The Sizewell C Project

Notification of Proposed Project Changes

PINS Reference Number: EN010012

October 2020

DRAWING NO:
 FIGURE 1

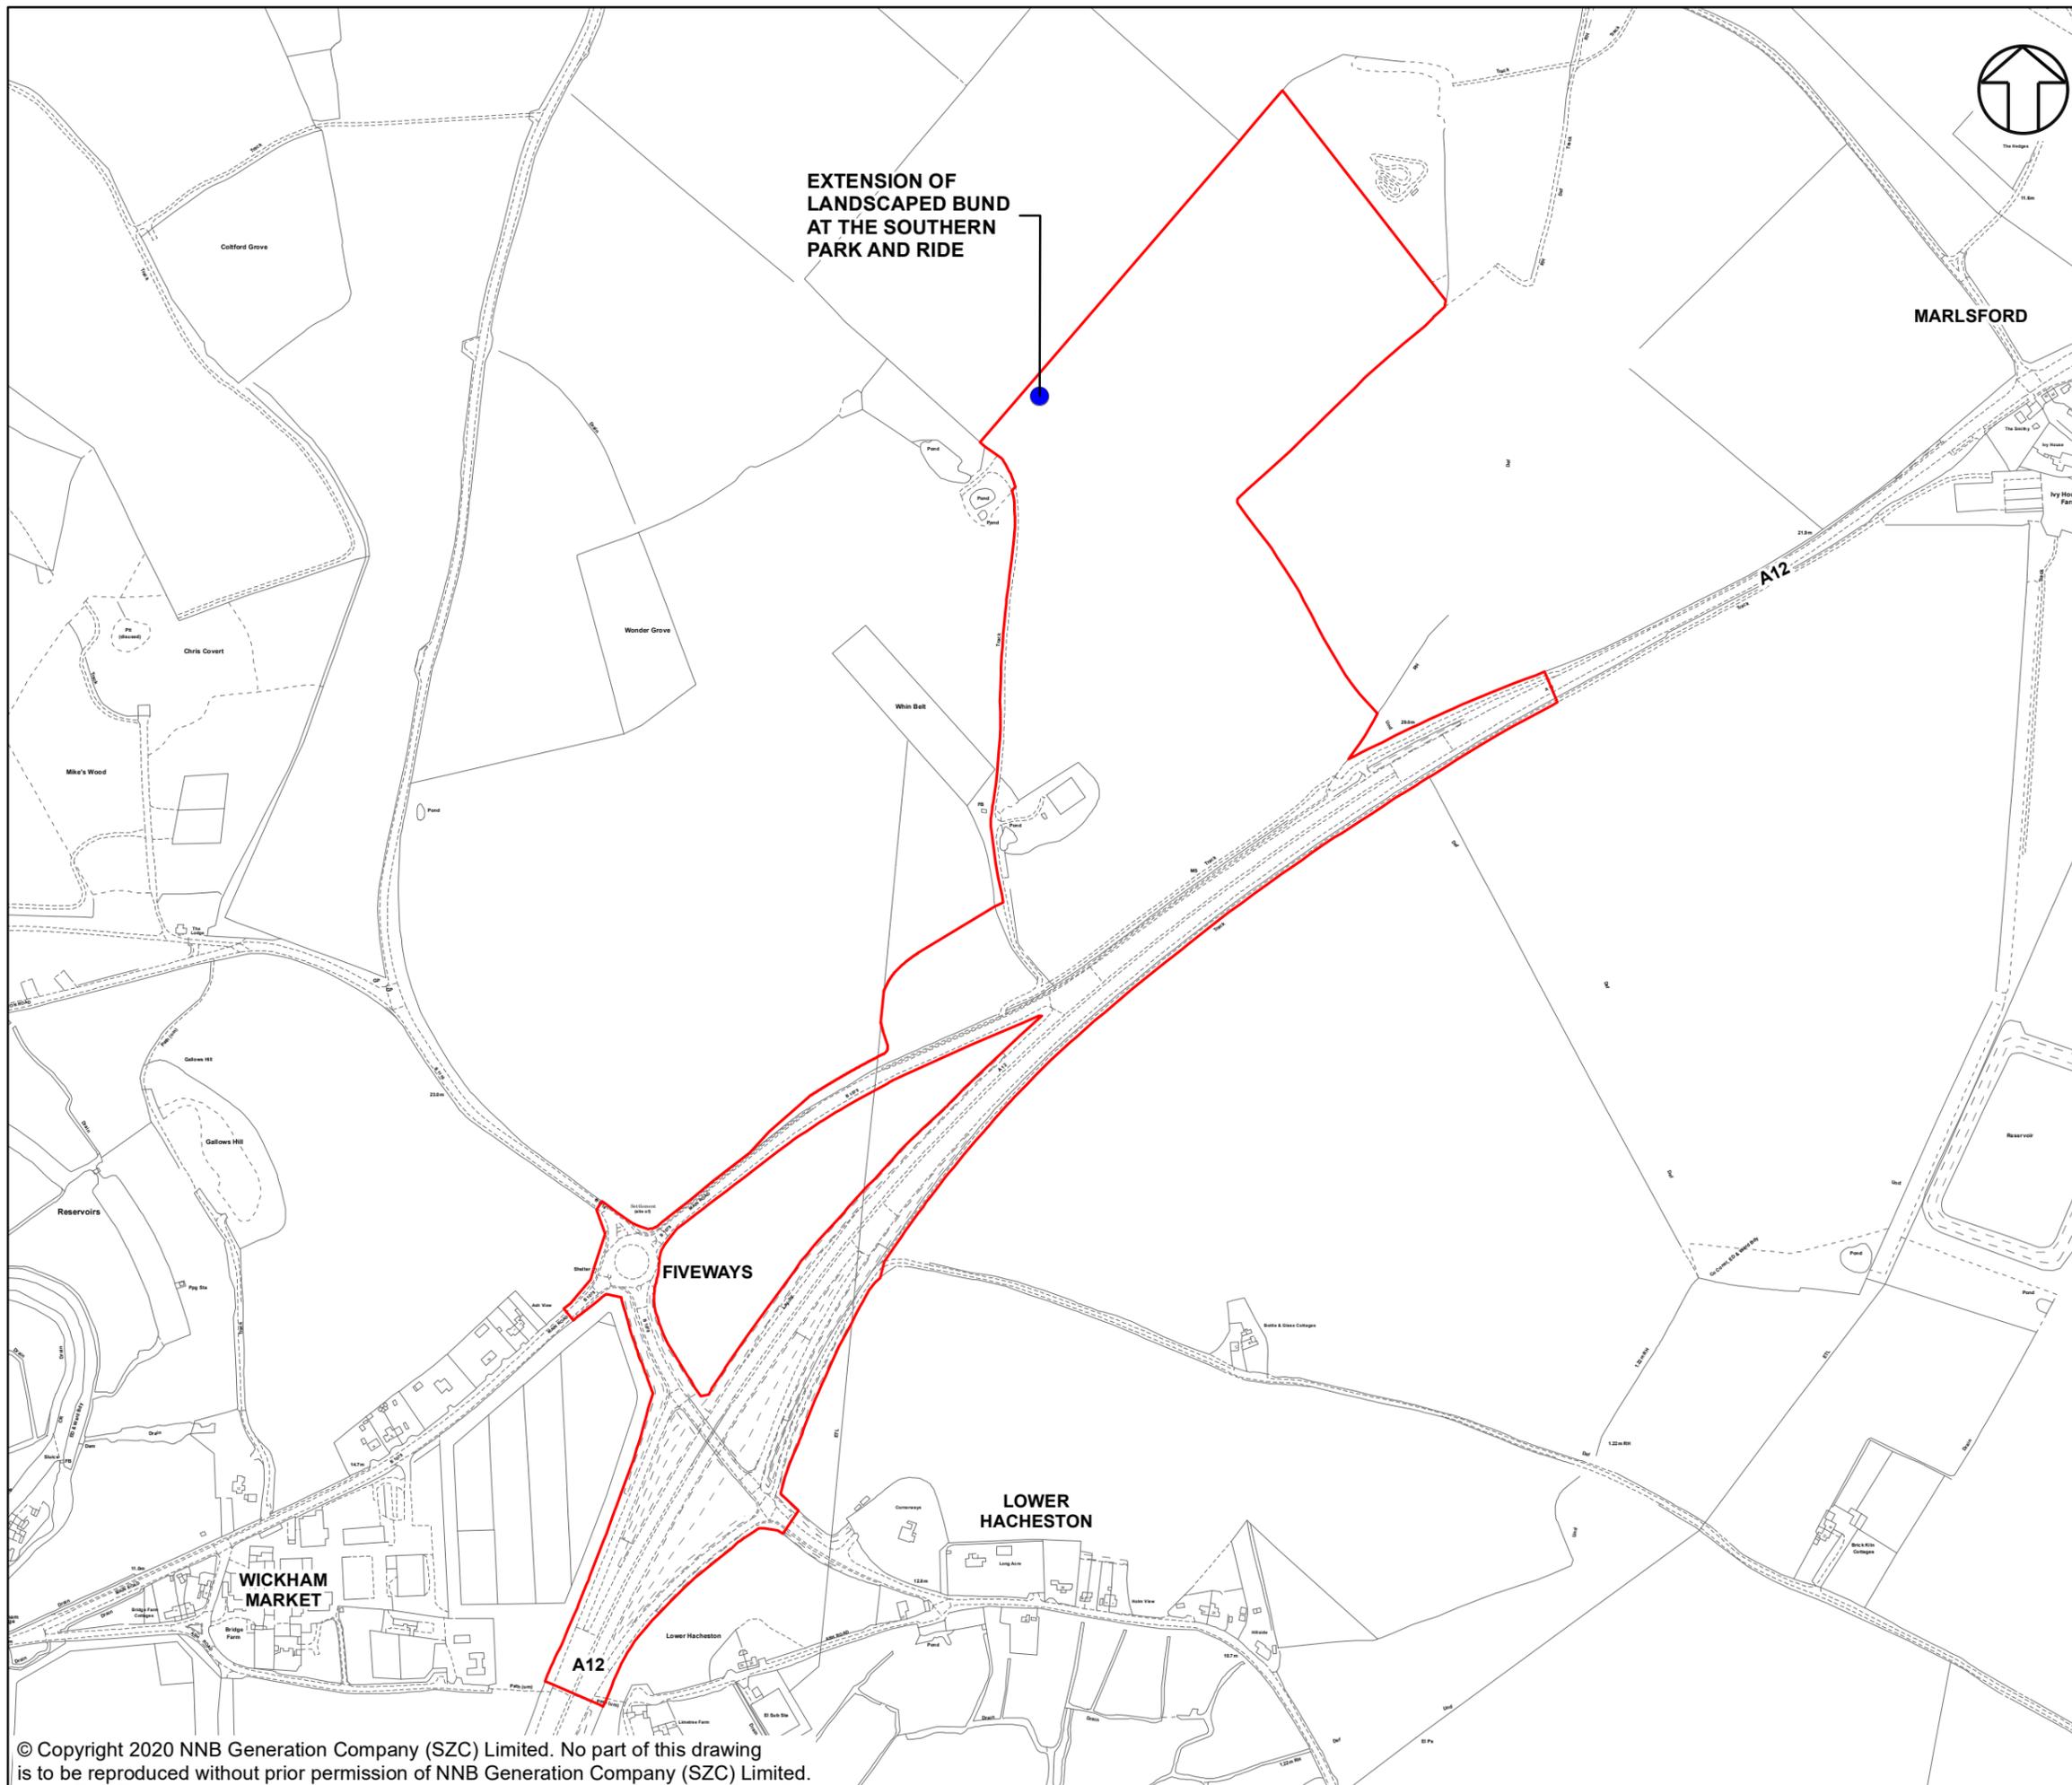
CHANGE TO THE DETAILED LOCATION OF THE WATER RESOURCE STORAGE AREA AND THE ADDITION OF FLOOD MITIGATION MEASURES

CHANGE TO PART OF THE SSSI CROSSING STRUCTURE TO INTRODUCE FLOOD RELIEF CULVERTS

CHANGE TO THE BEACH LANDING FACILITY DESIGN

DRAWING NO:
FIGURE 2

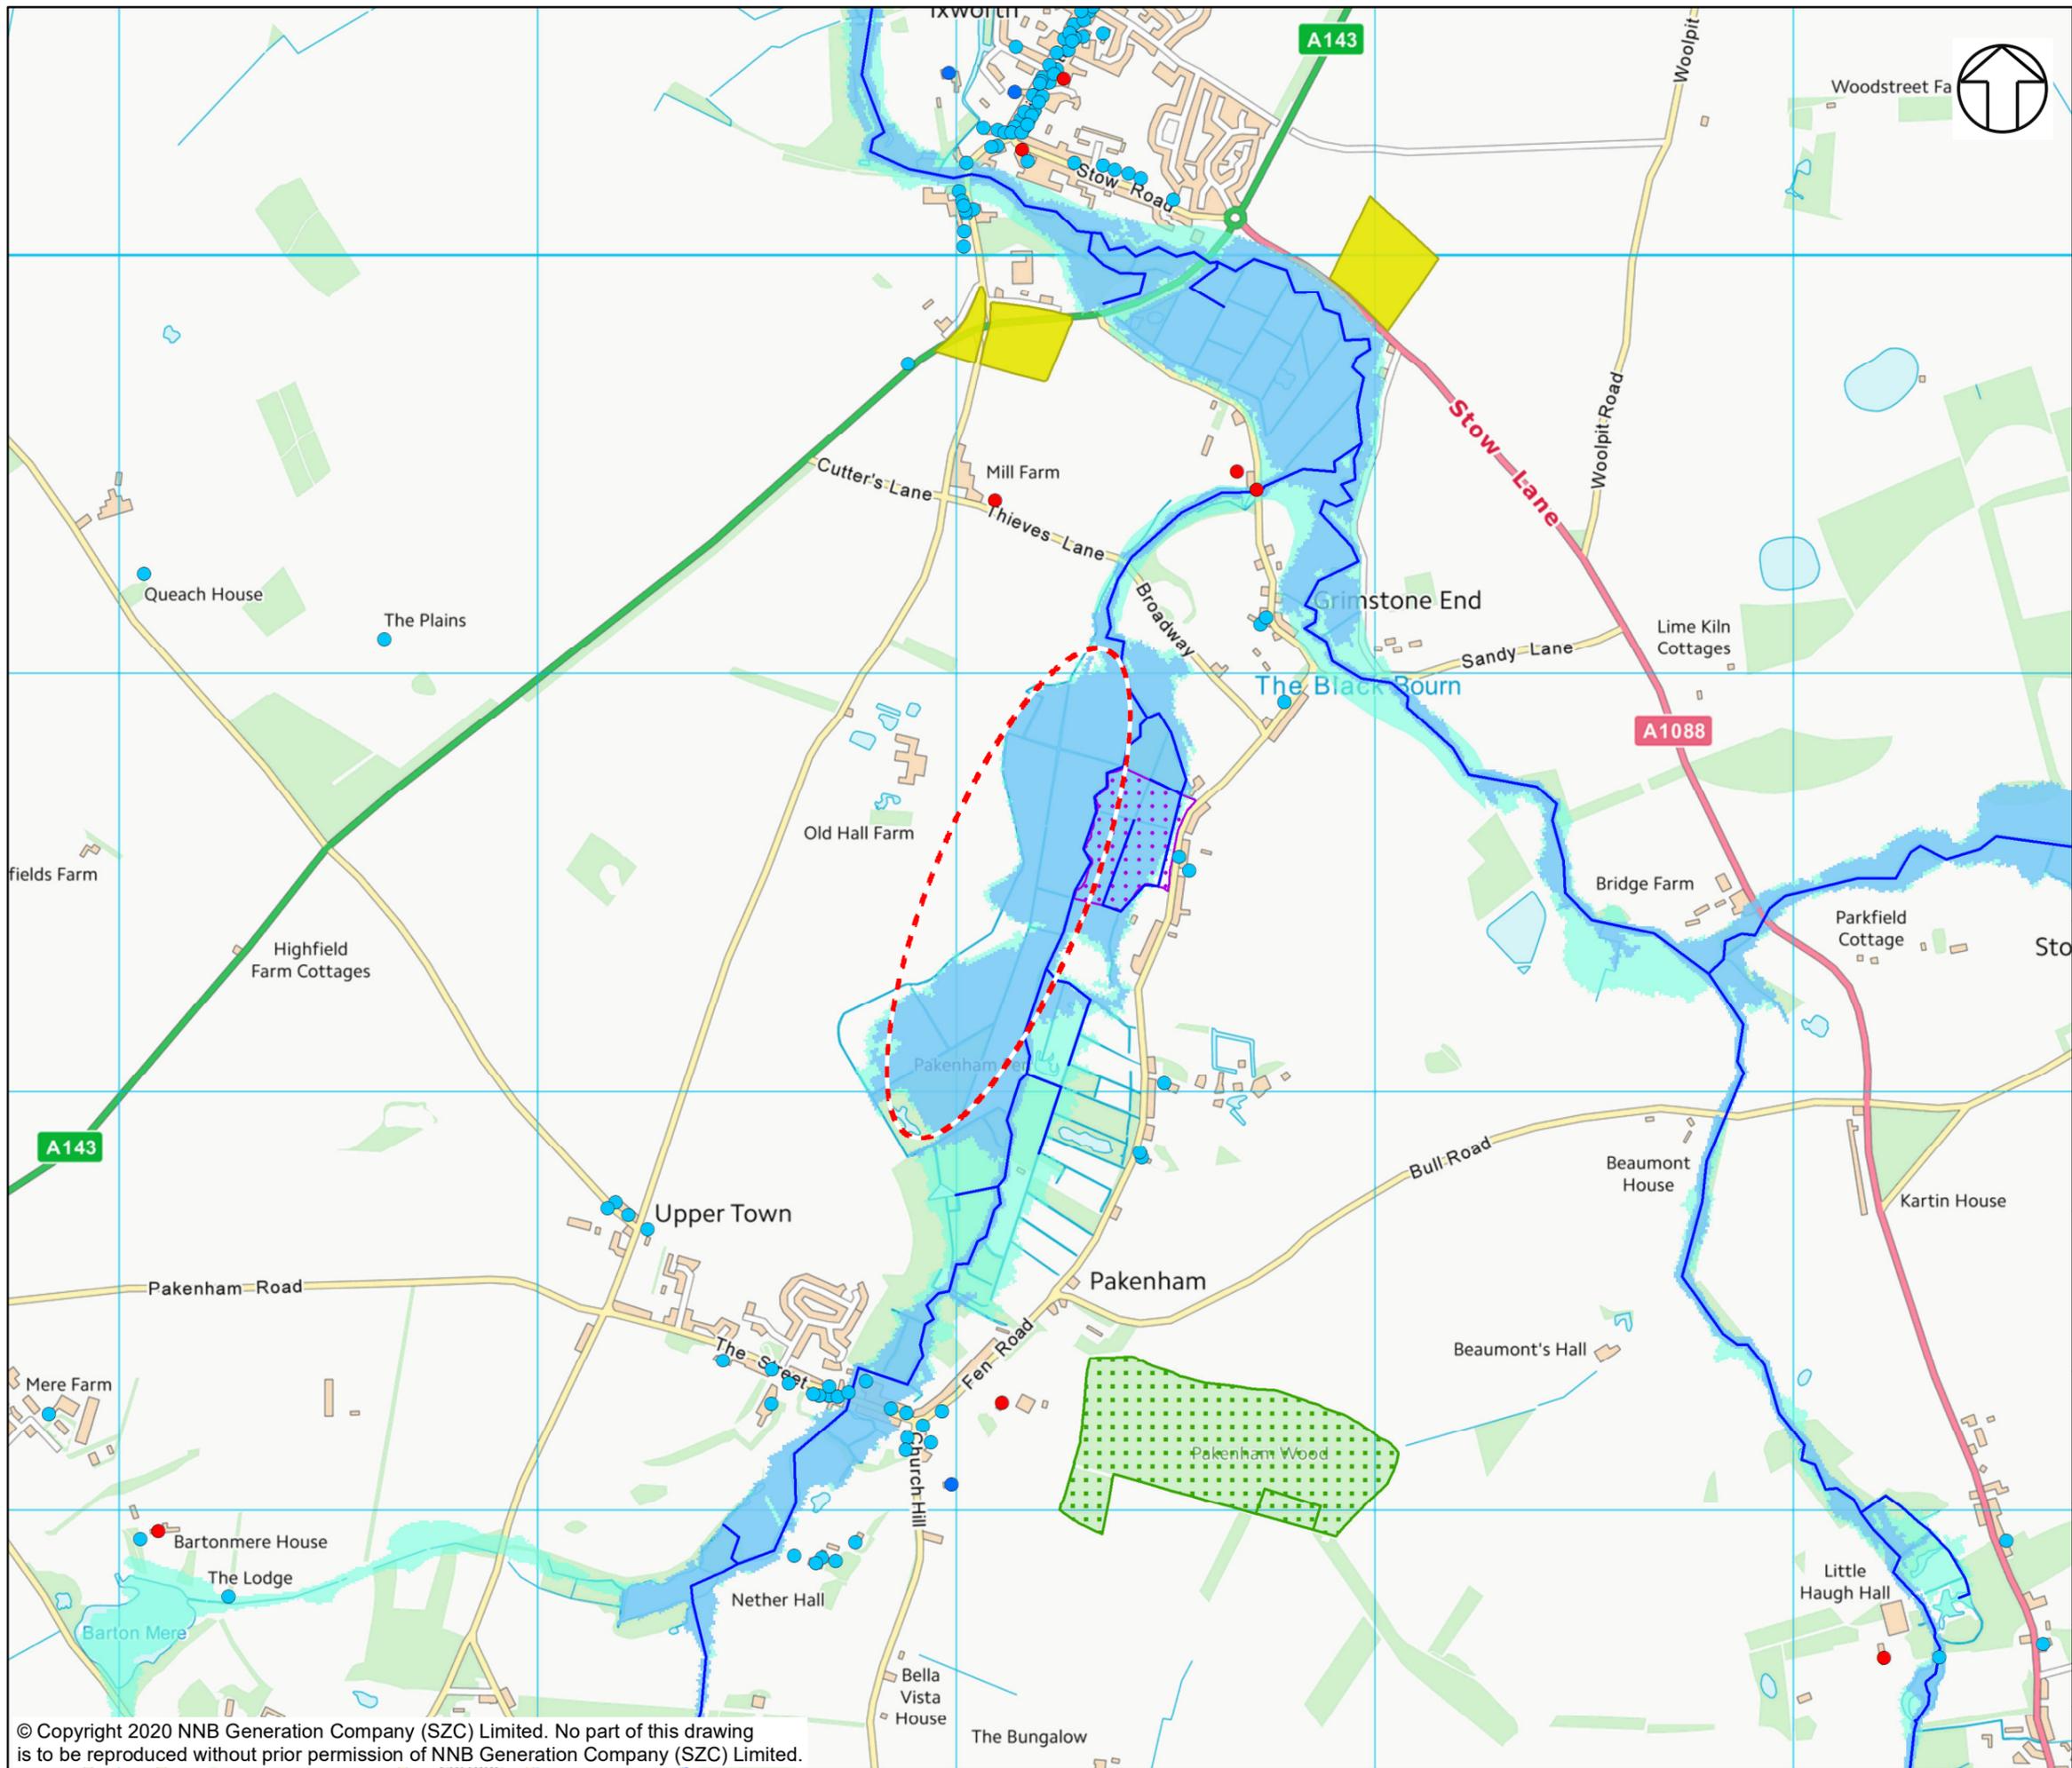
- e) [Change 10: Extension of landscaped bund and other minor potential design changes at the Southern Park and Ride](#)
- 2.3.24 The Project proposes a landscaped bund along part of the northern boundary of the Southern Park and Ride adjacent to the Traffic Incident Management Area (TIMA).

- 2.3.26 SZC Co. intends to extend the landscaped bund for the full length of the TIMA along this northern edge up to the 10-metre buffer zone to the south-west, following feedback from stakeholders. The area is already well screened from views to the west, however the addition would provide some additional screening to views from the B1116 and a nearby footpath.
